Change Order

Williamson County
Animal Shelter Expansion
1855 SE Inner Loop
Georgetown, TX 78626

Change Order Number: 007

Change Order No. 7 includes the below listed Vaughn Change Proposals # 32-#39 and #41-42. For Vaughn Project No. 2491-01.

ENLARGED PLANS &
INTERIOR ELEVATIONS

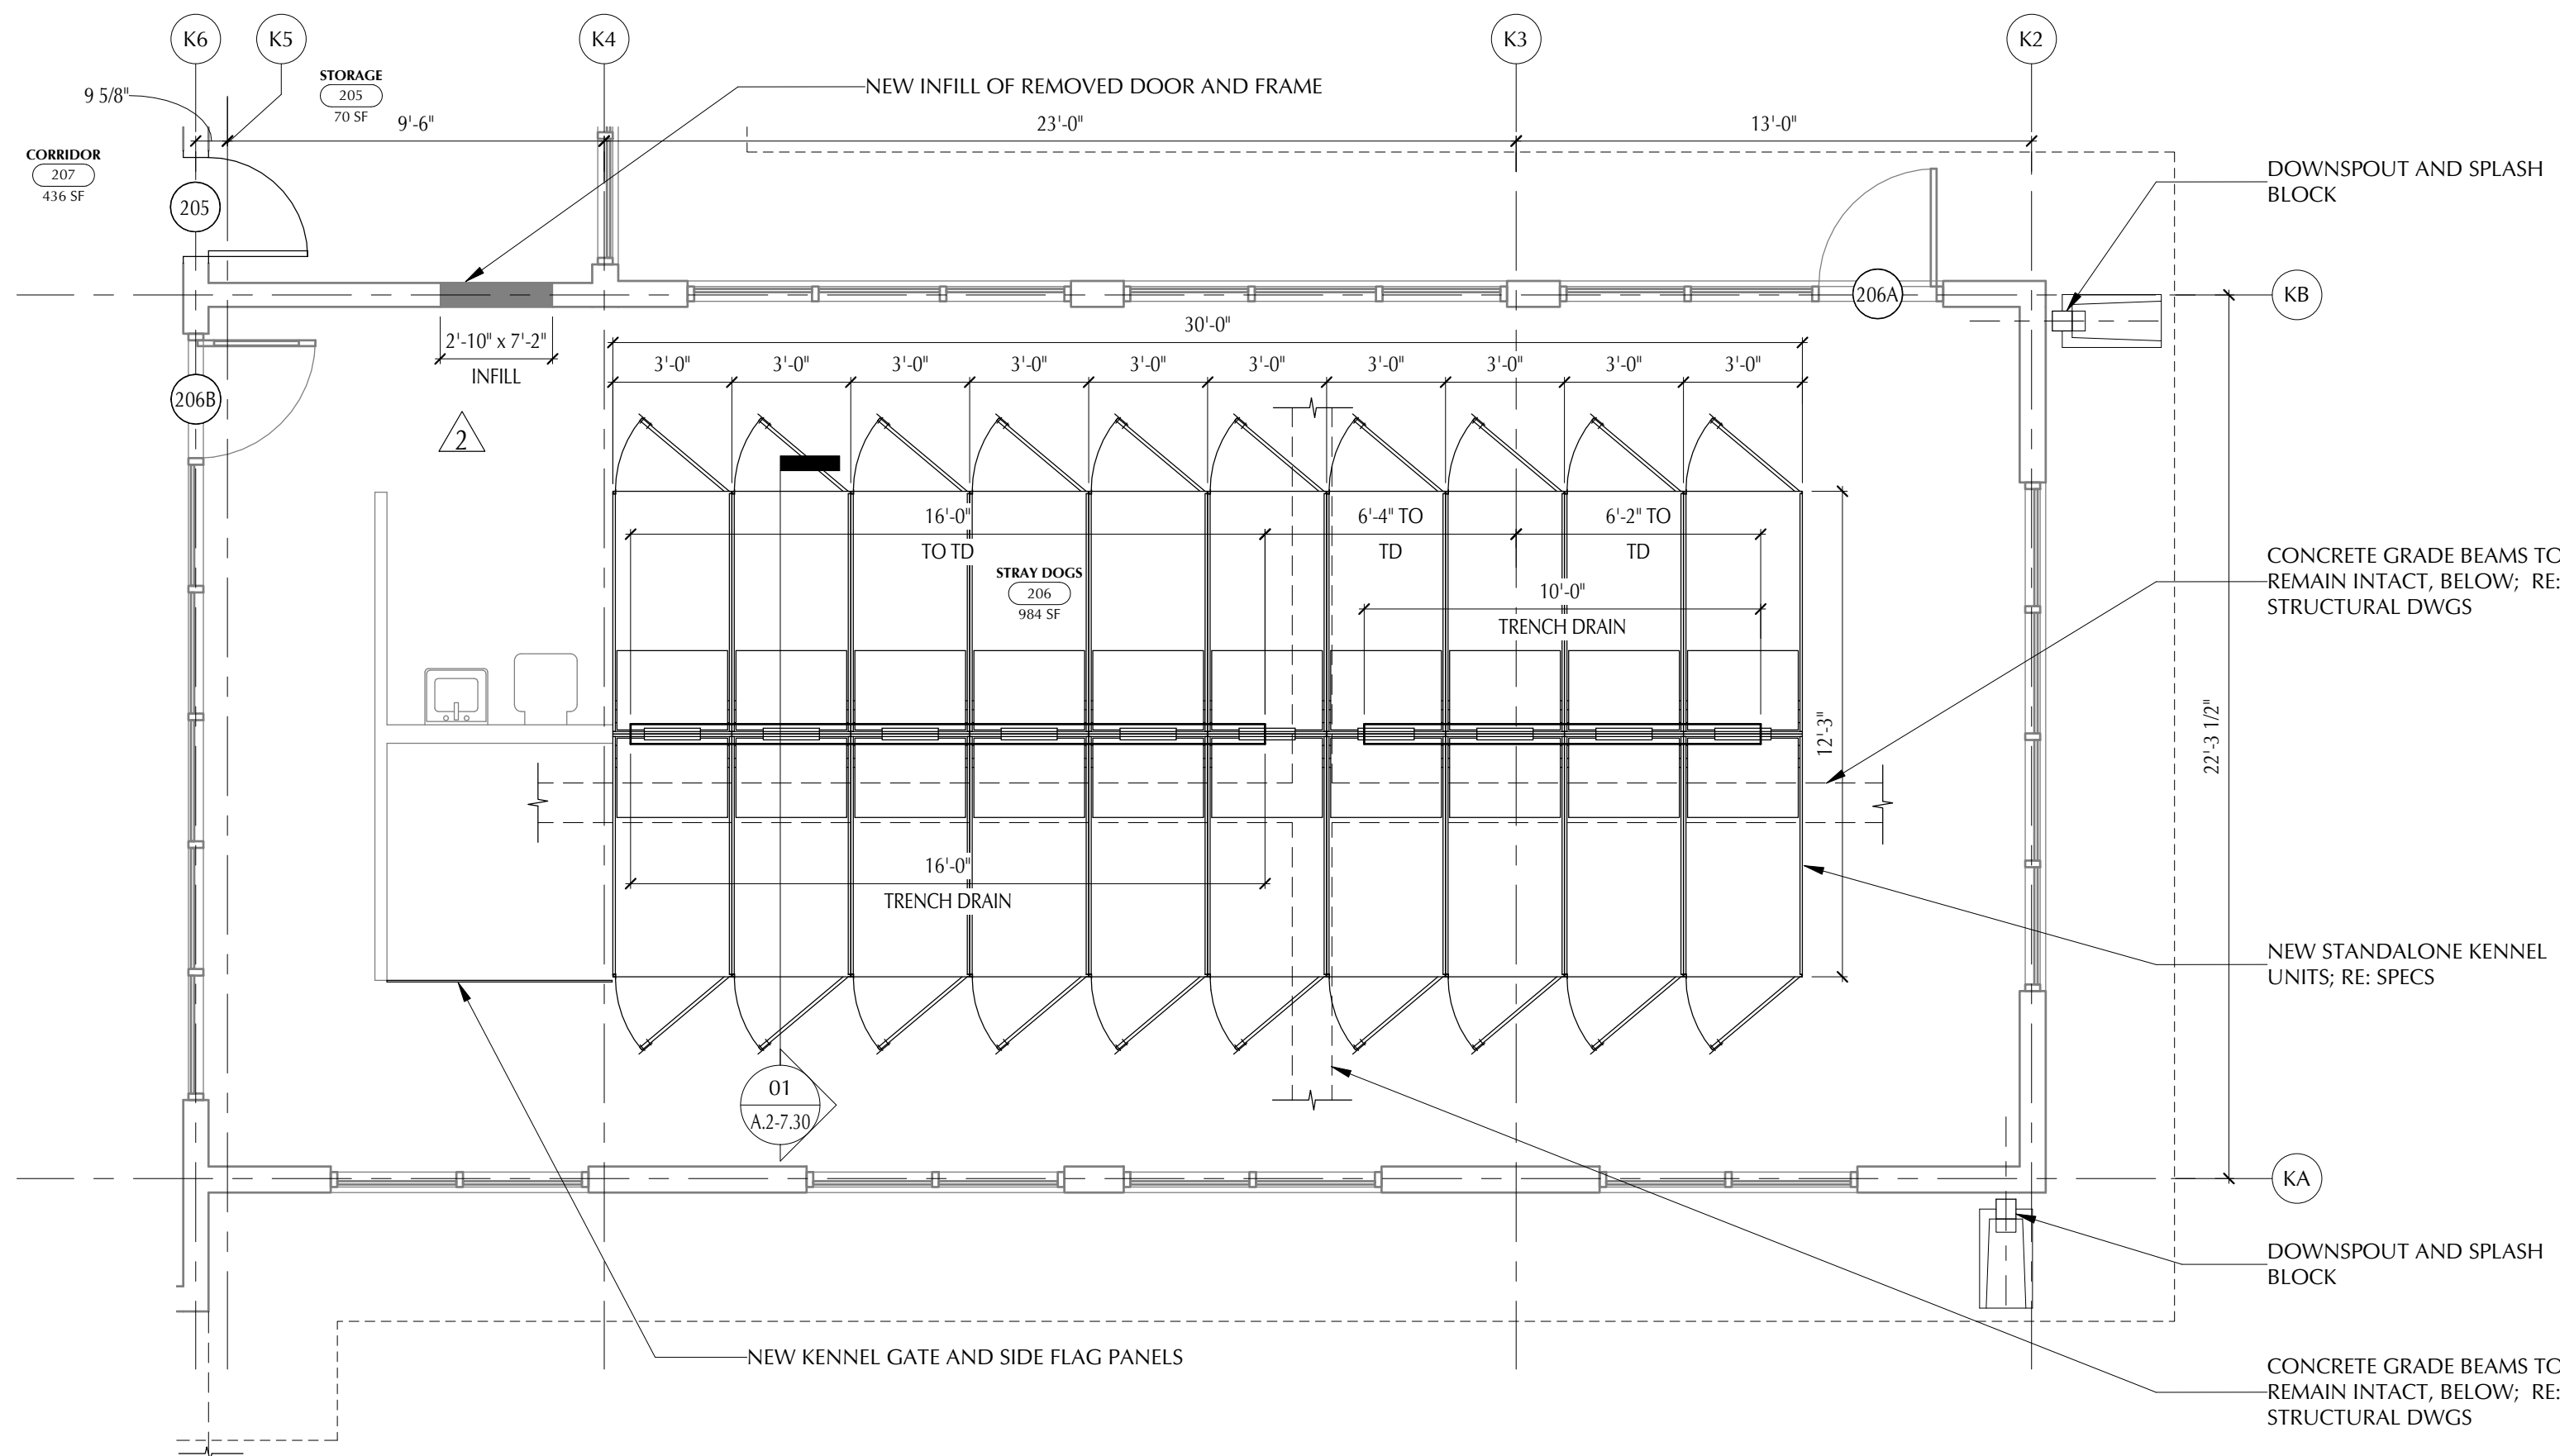
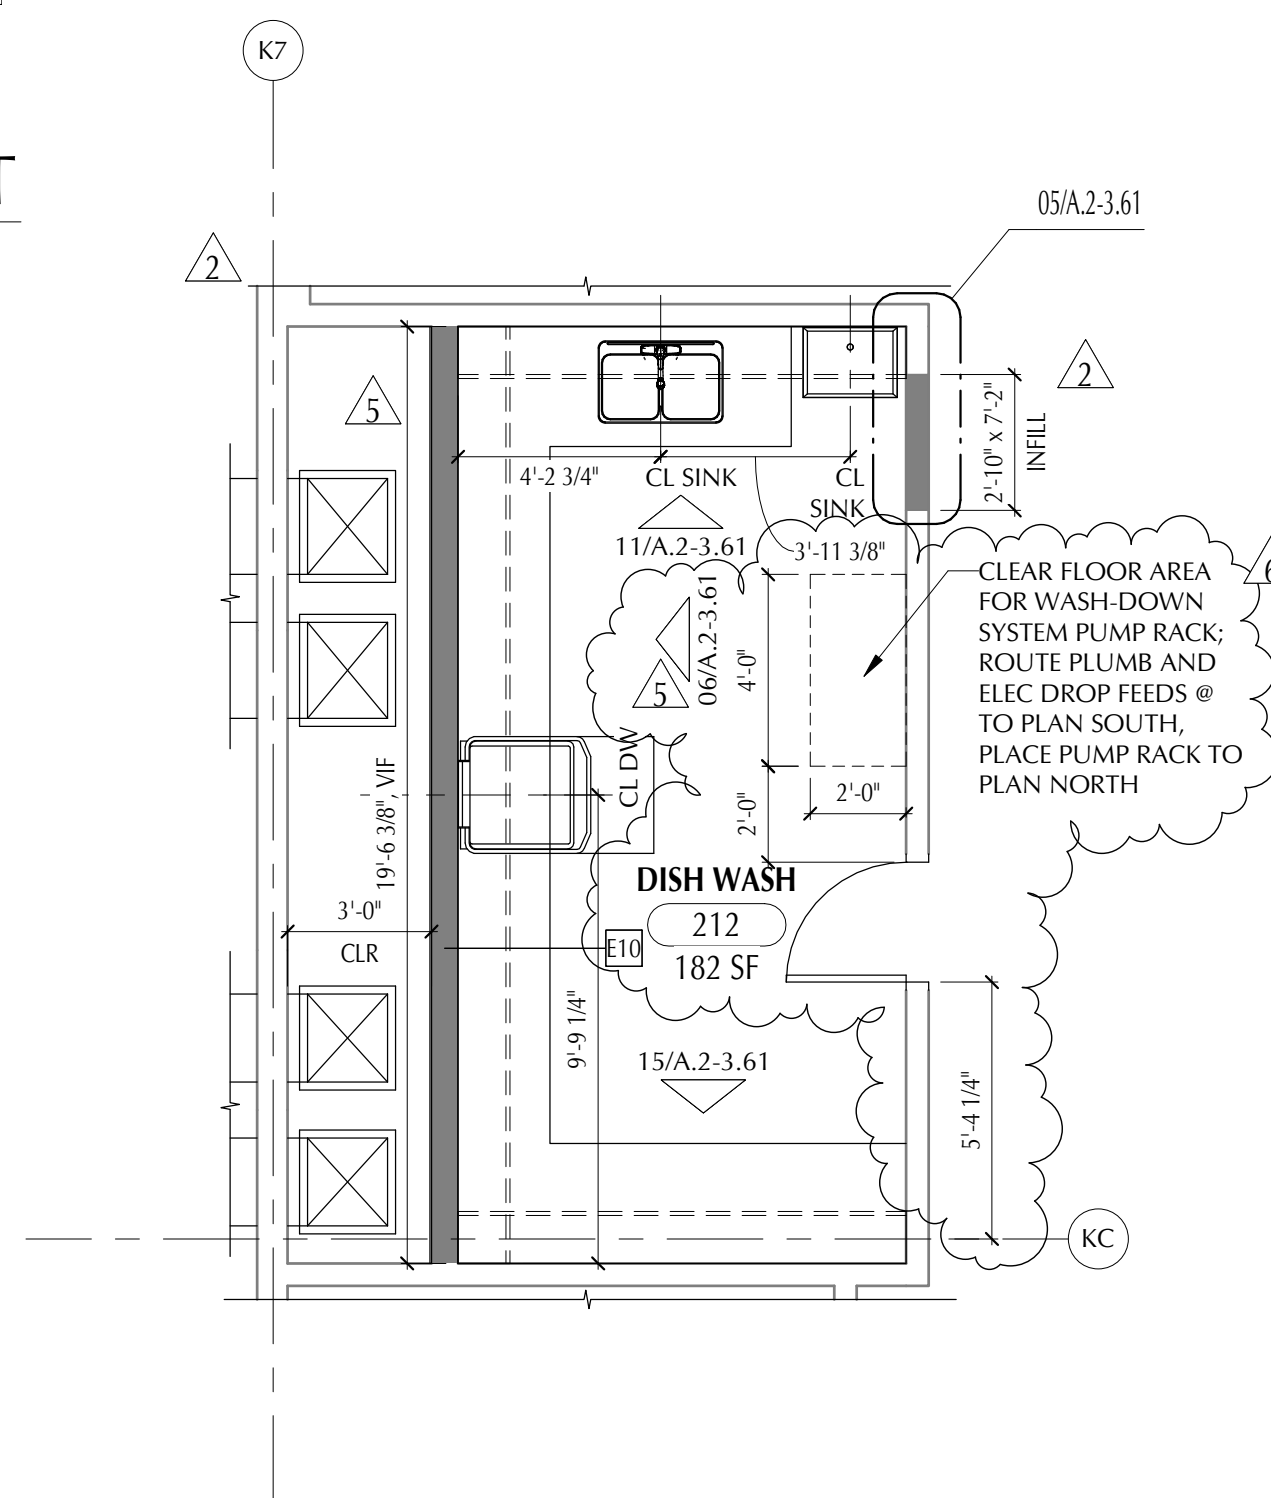
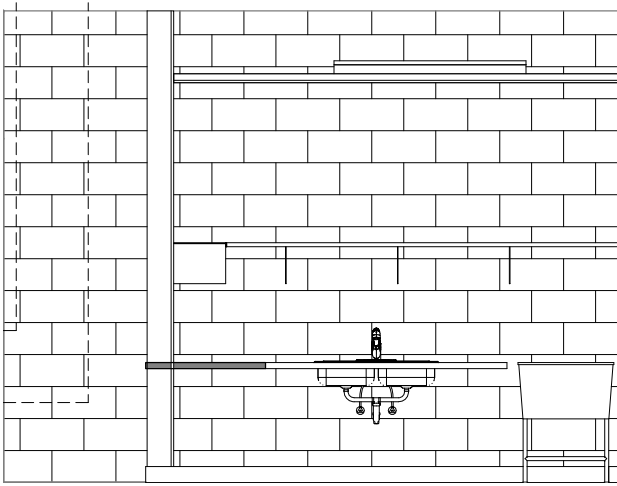
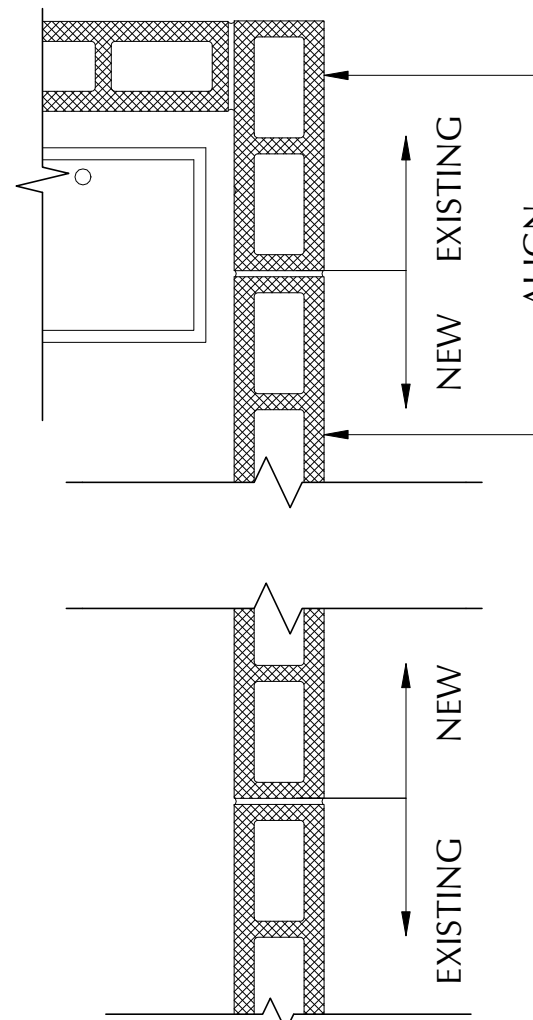
We respectfully submit our proposal for an increase to our contract in the amount of \$0 (zero) dollars to provide installation of water supply for SMT System per ASI 007 issued by Jackson & Ryan for the above referenced project.

DESCRIPTION OF WORK: Work Added per ASI 007
